LOUVRE
BAS CONTINUOUS LINE PRESSED ALUMINIUM ACOUSTIC LOUVRE SYSTEM
BAS L105P
APPROXIMATE WEIGHT - 24KG/M2

NOTES RELATING TO STEELWORK AND LOUVRE SYSTEM SETTING-OUT

1:20 (@ A1) SCALE CORNER DETAIL USING PERIMETER LINE OF LOUVRE SCREENS TAKEN FROM PURCELL DRAWINGS AND SHOWING ACCURATELY SIZED UKC 203x203x52 WHICH IDENTIFIES POTENTIAL CLASH WITH EXISTING RWO (UKB & RWS THAT SUPPORT UKC NOT SHOWN)

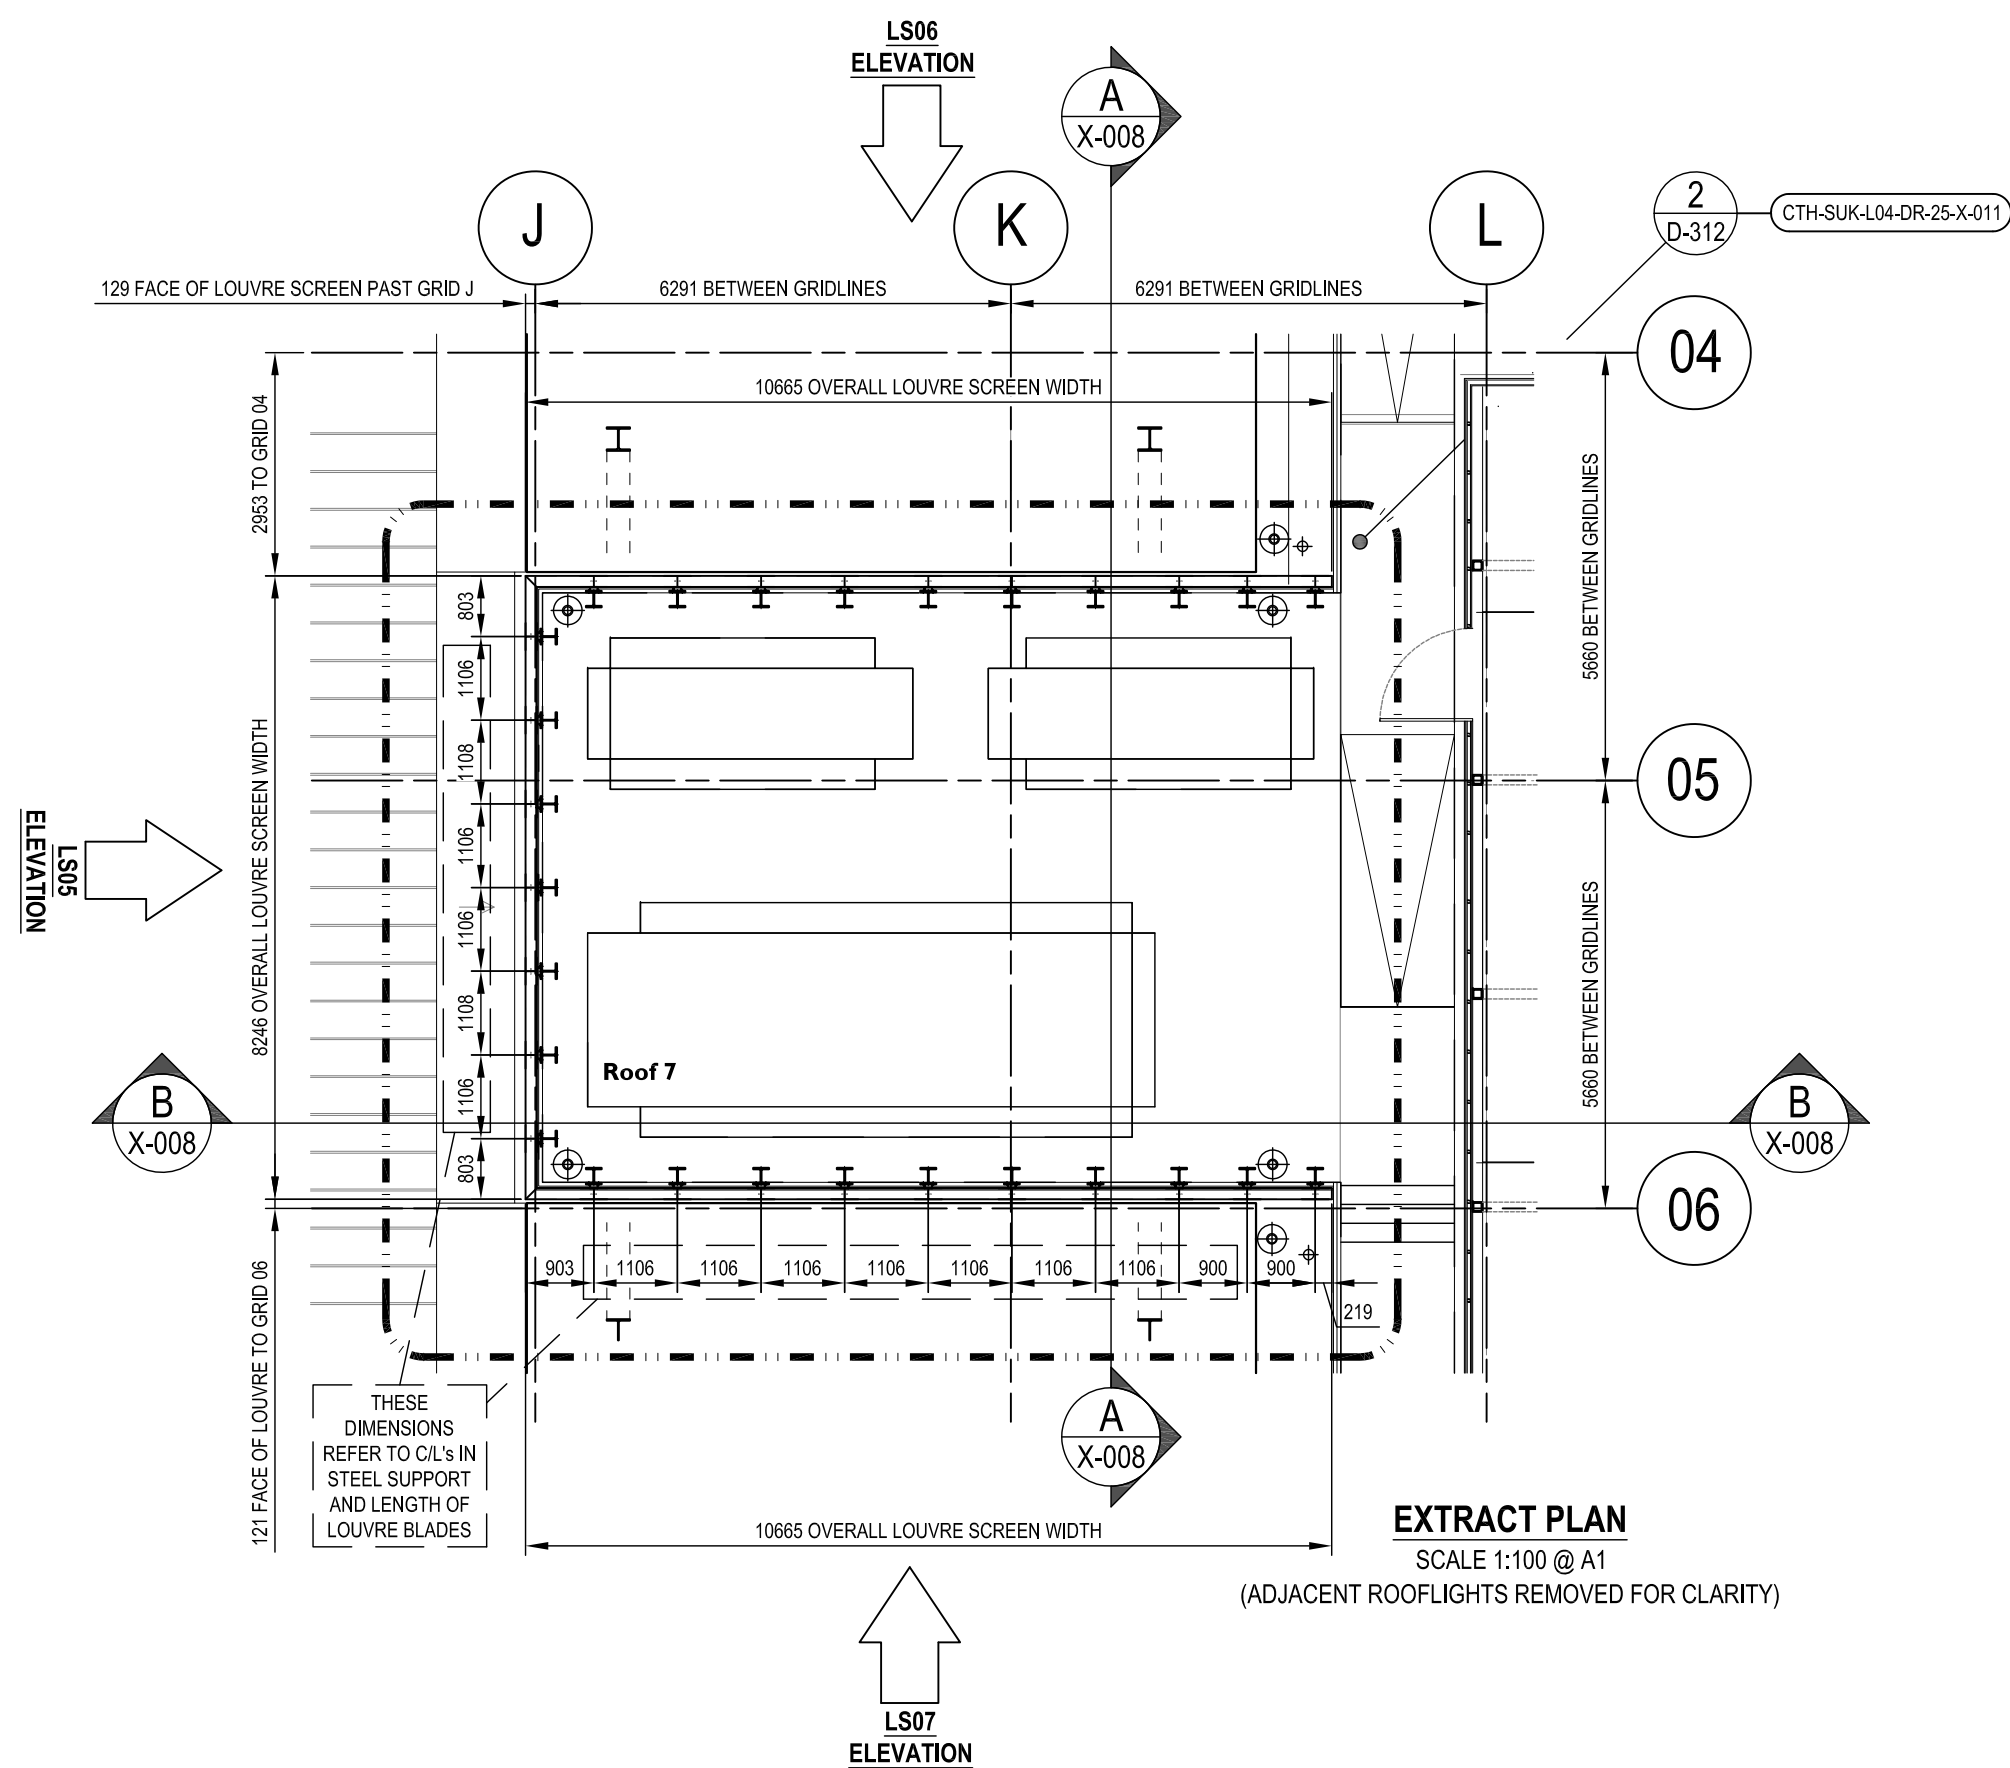
IN ANTICIPATION OF REVISED AND ACCURATE STEELWORK DRAWINGS WE HAVE DETAILED AN ALTERNATIVE SETTING-OUT OF THE STEEL COLUMNS AS A SUGGESTION ONLY. SUBJECT TO FUTURE CO-ORDINATION
